The Network Rail (Cambridge South Infrastructure Enhancements) Order

NRE-REB-06

Rebuttal Evidence to OBJ-23 (Cambridge City Council)

January 2022

Figure 1 – Footpath south of the guided busway

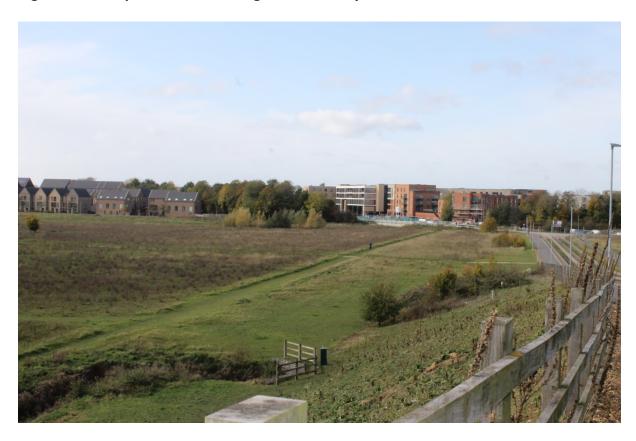
3.1.1 Paragraph 5.1 (a) (ii). The proposed exchange land although compensatory in respect of size, does not address the impact of disaggregation of Hobsons Park due to the introduction of the Station, its forecourt and access paths. For example, the creation of smaller parcels of land south of the Cambridge Guided Busway and between the new footpath networks, the areas of land around the Station, and the reconfiguration of the land south of Addenbrookes Access Road, all of which have limited future recreational uses.

- 3.1.3 I note that Cambridge City Council has not objected to the application for the Open Space Certificate.
- 3.1.4 I am advised that there is no legal requirement for NR to provide replacement land other than in relation to land which is being permanently acquired. In any event, I do not consider that the CSIE Project results in adverse disaggregation as Mr Wilson suggests.
- 3.1.5 The area of Hobson's Park south of the guided busway is already disaggregated by a publicly accessible pedestrian path, albeit constructed from reinforced grass (Figure 1 below). The proposals, which would replace this path with a hard surface, would therefore not bring about significant further disaggregation.

3.1.6 The land either side of this existing reinforced grass path forms part of the wildflower meadow areas of Hobson's Park. These areas are
